METFORD MEDICAL

ARCHITECTURAL DRAWING SCHEDULE

ISSUE FOR DA

REVISION 2 UPDATES (01/12/23)

1 NORTH ELEVATION - BUILDING B

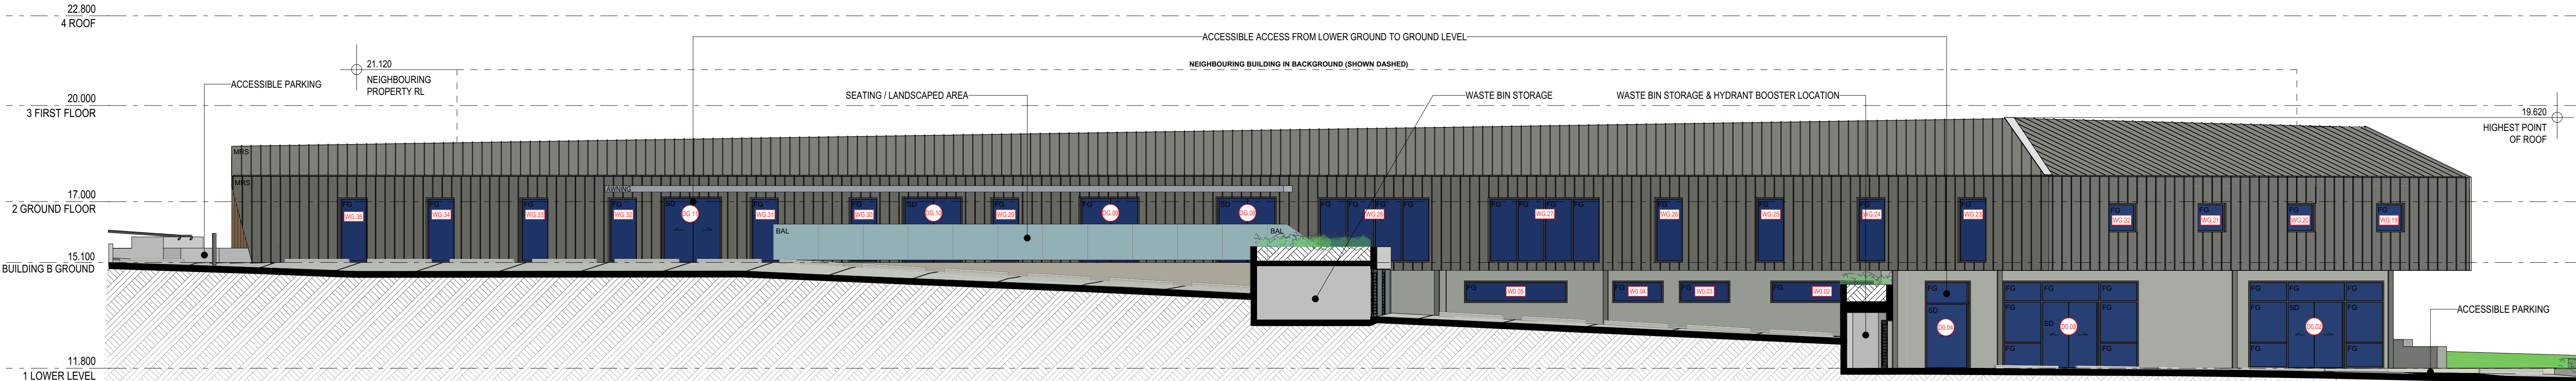
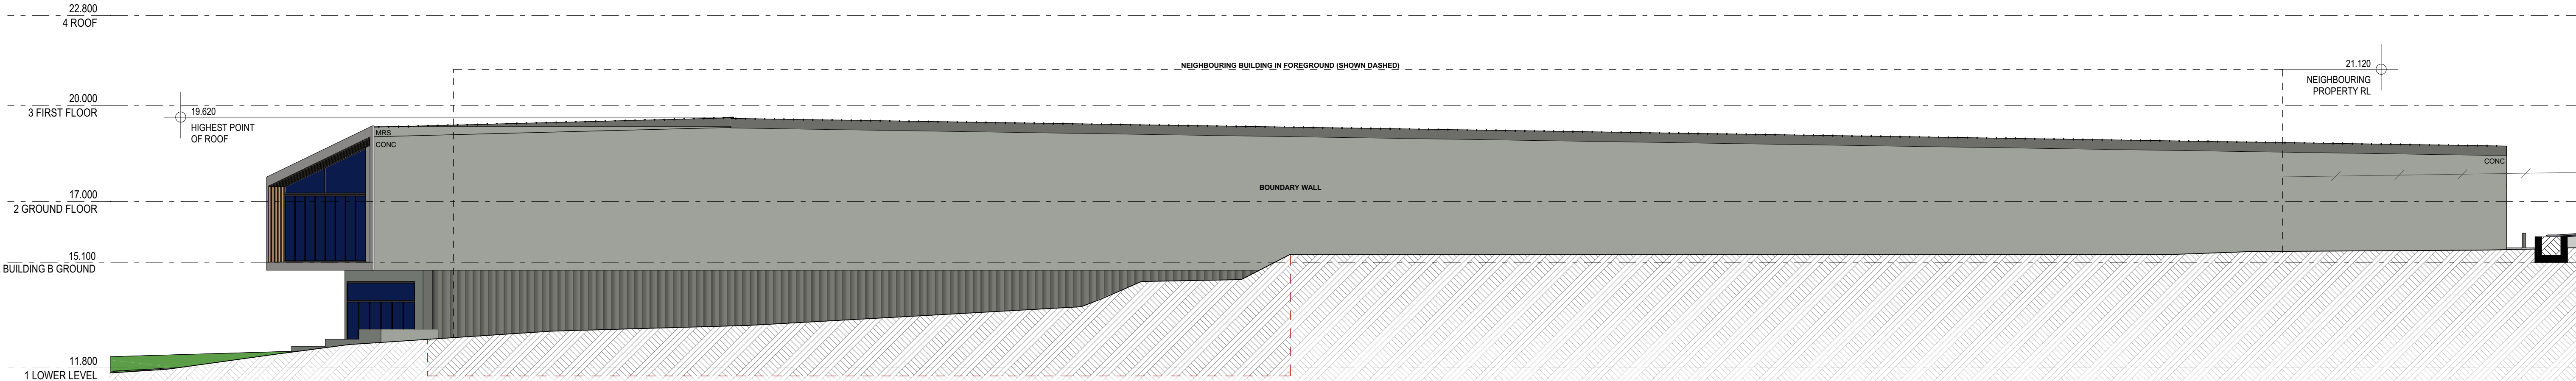
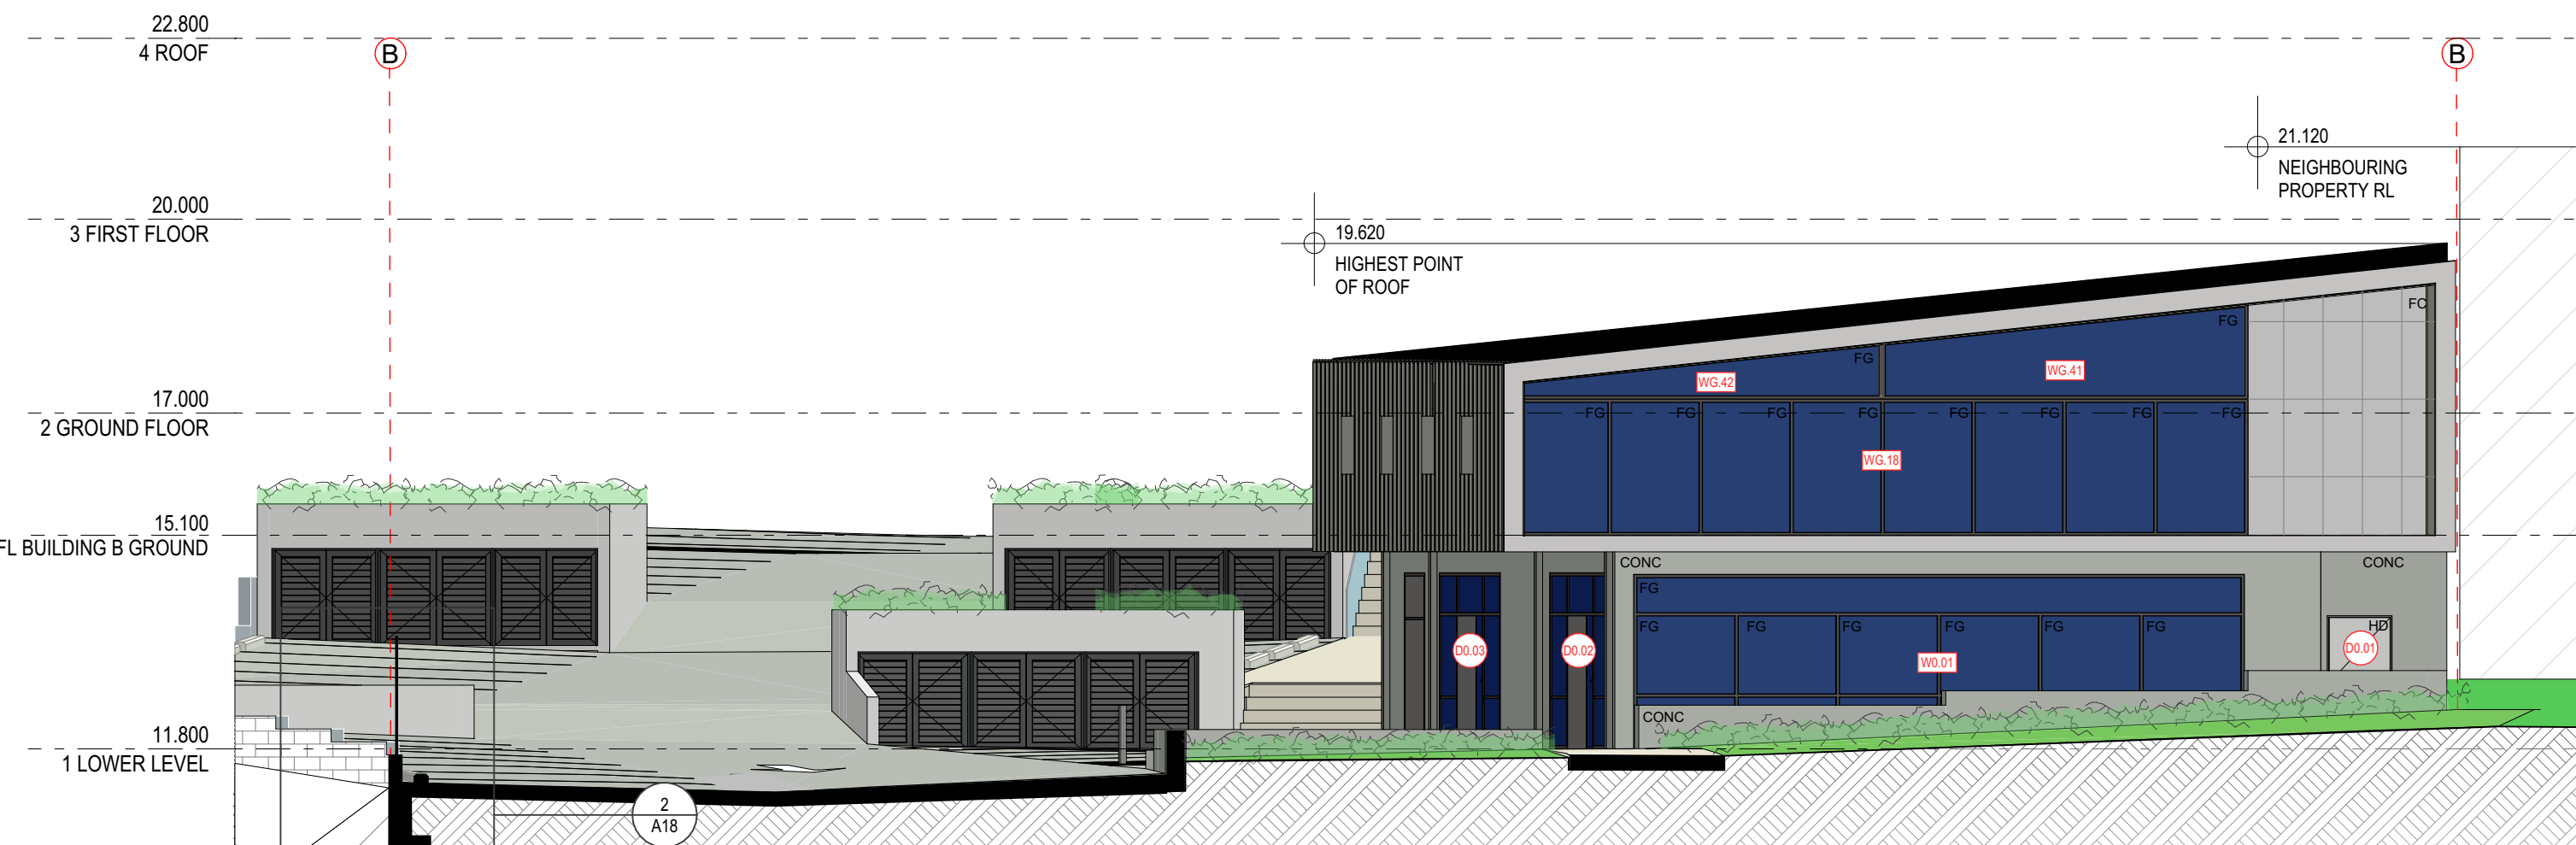
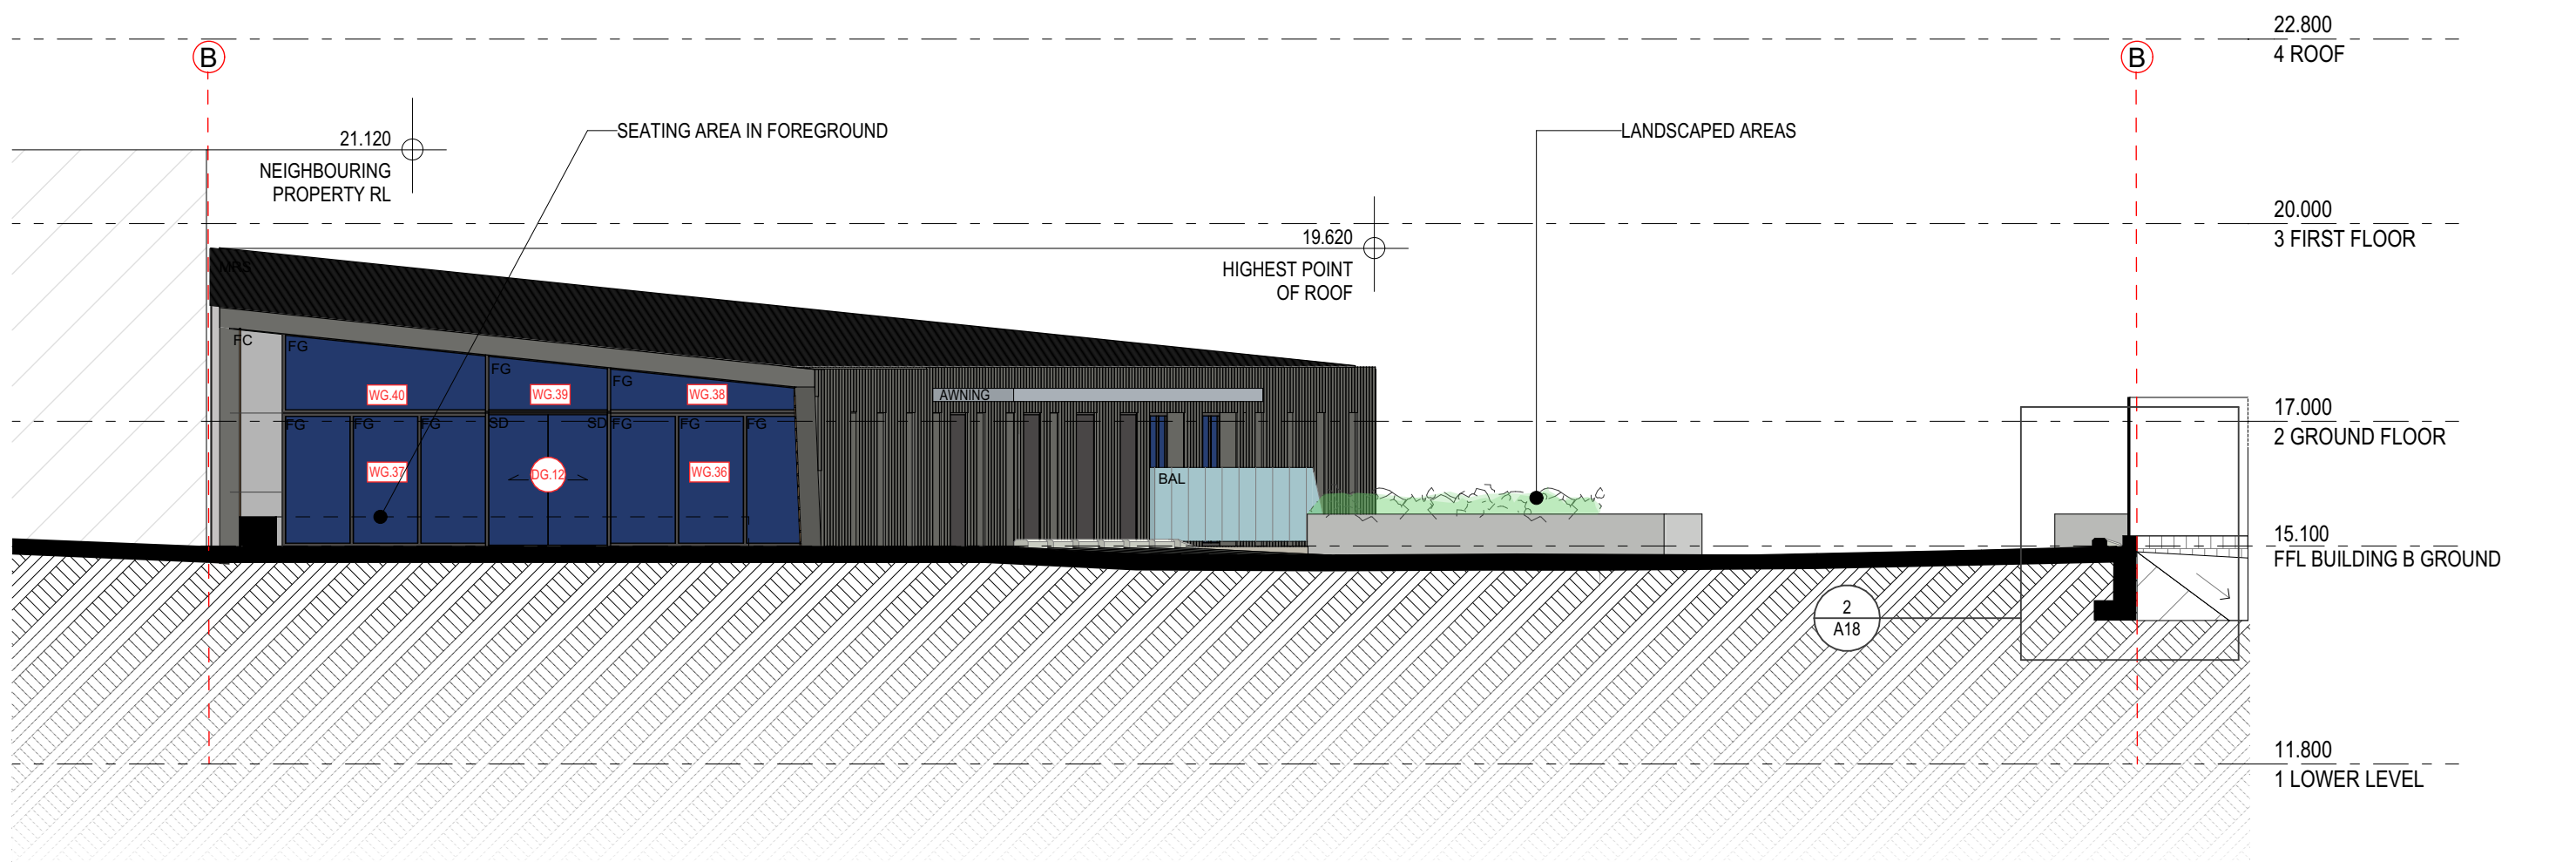
REVISION 2 UPDATES (01/12/23)
- BOUNDARY RETAINING WALL DETAILS SHOWN

DRAWING: BUILDING B - SECTION A-A, B-B, C-C, D-D

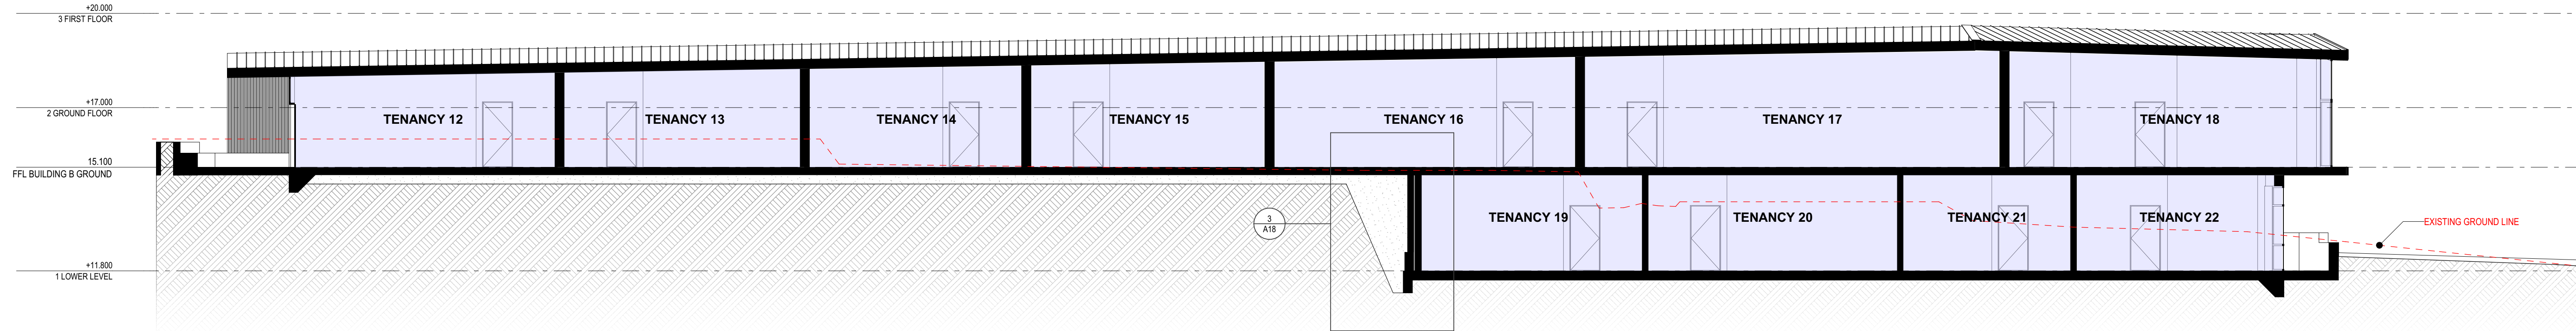
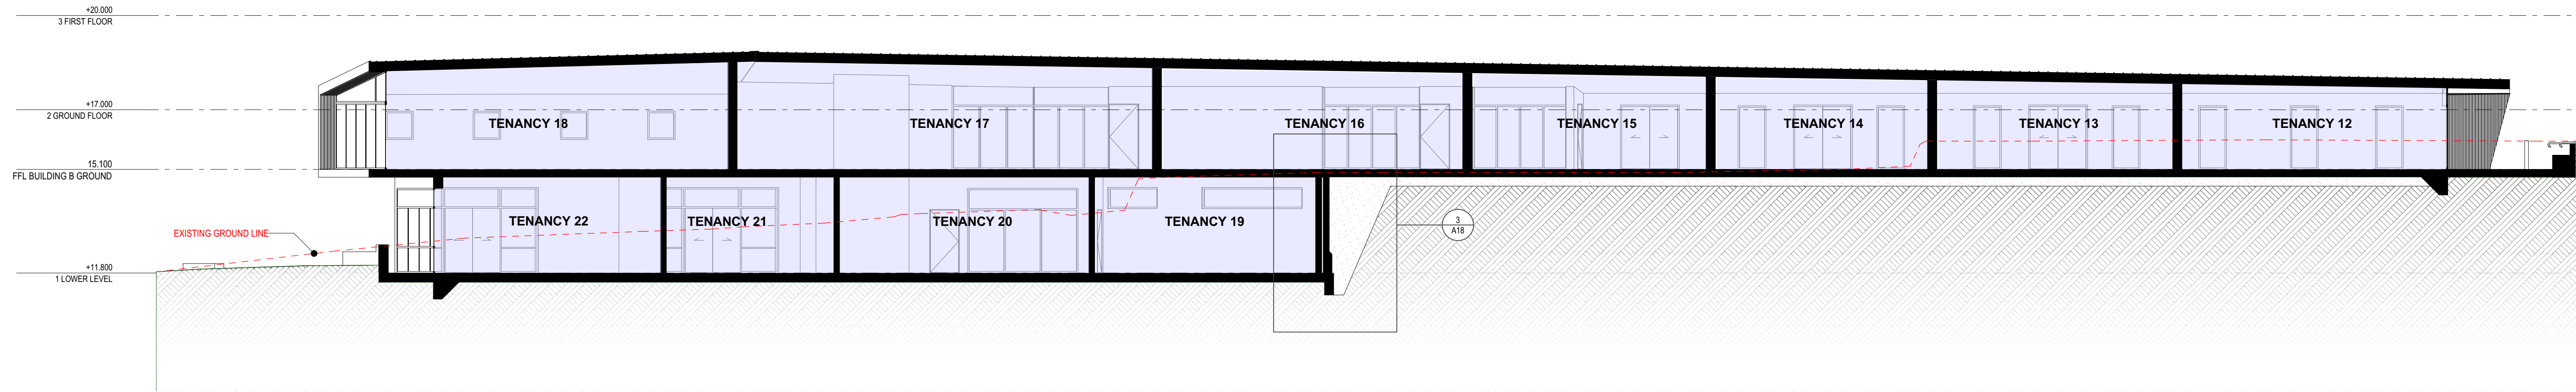
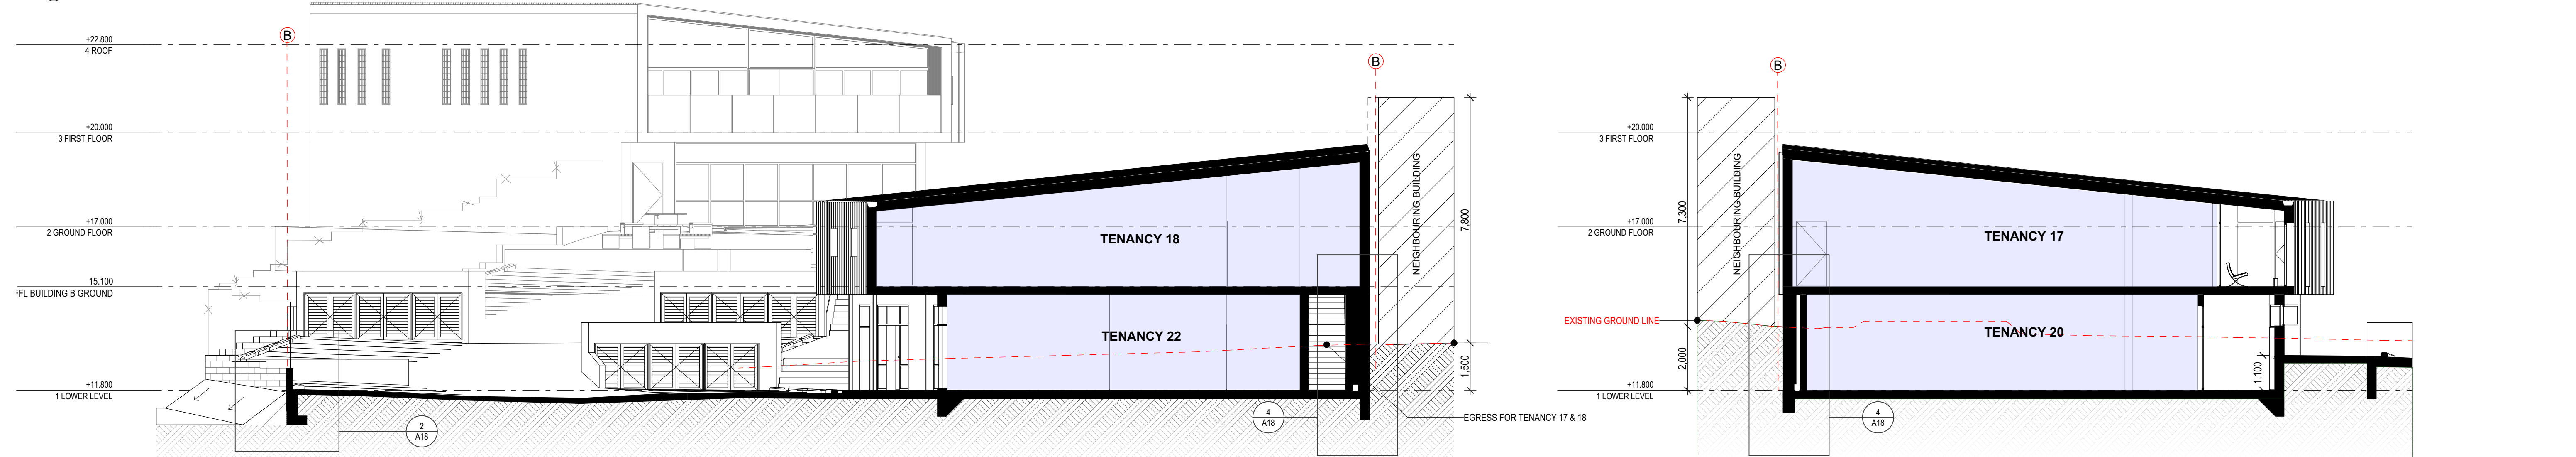
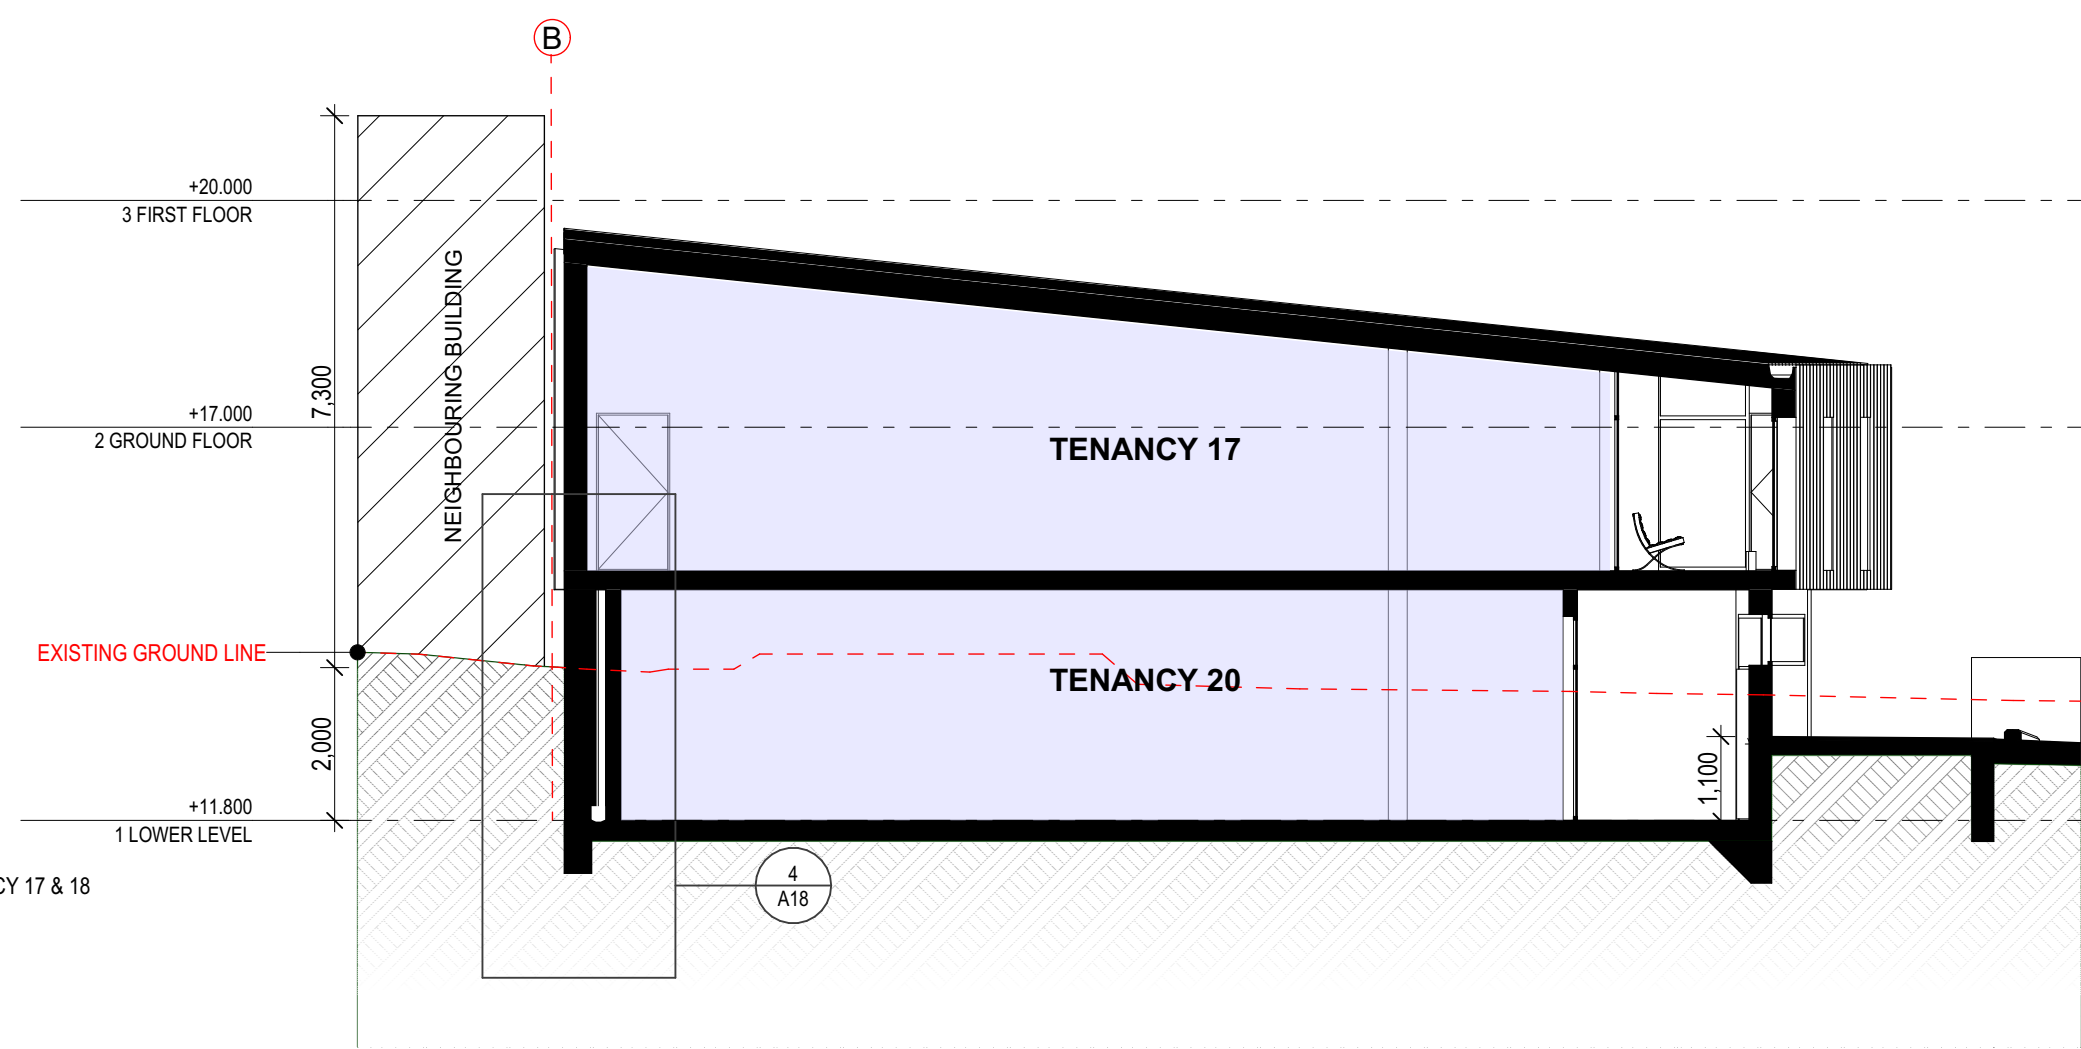
REVISION 2 UPDATES (01/12/23)
- BOUNDARY RETAINING WALL DETAILS SHOWN
